UTAH DEPARTMENT OF TRANSPORTATION
Region 2

I-80 Jeremy Ranch Exit; MP 141

PIN 13255

UDOT QC

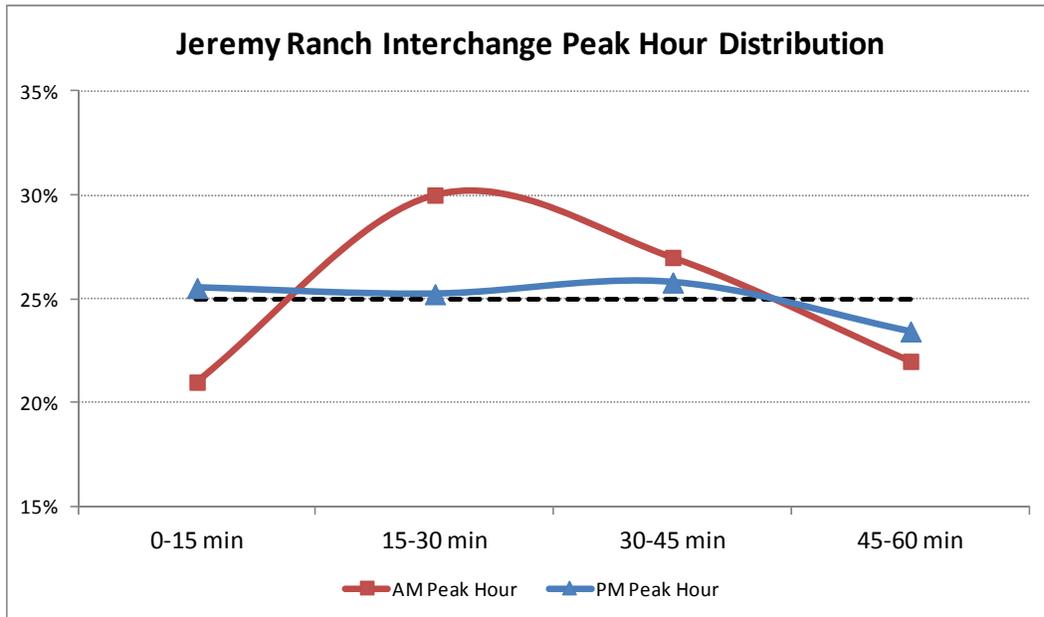
Note: The PHF represented in the model is not typical to traffic patterns in general. Verify that your volumes represent projected conditions. **Peak hour distribution is coded according to actual peak hour fluctuation from data collection. The graph below illustrates the interchange peak hour volume distribution from the data collection.**

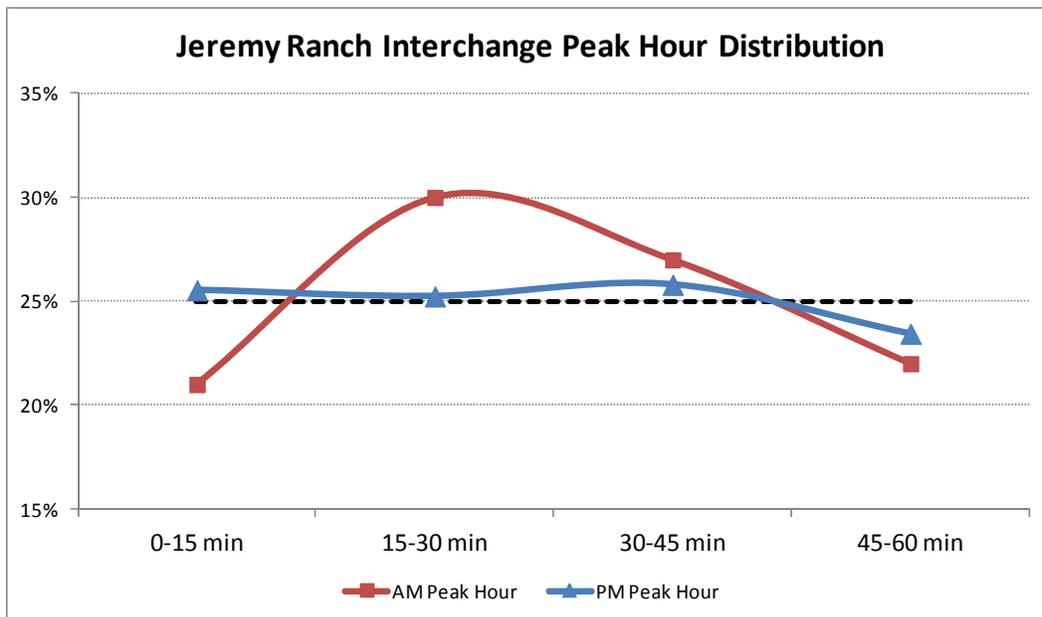
Note: The PHF represented in the model is not typical to traffic patterns in general. Verify that your volumes represent projected conditions. **Peak hour distribution is coded according to actual peak hour fluctuation from data collection. The graph below illustrates the interchange peak hour volume distribution from the data collection.**
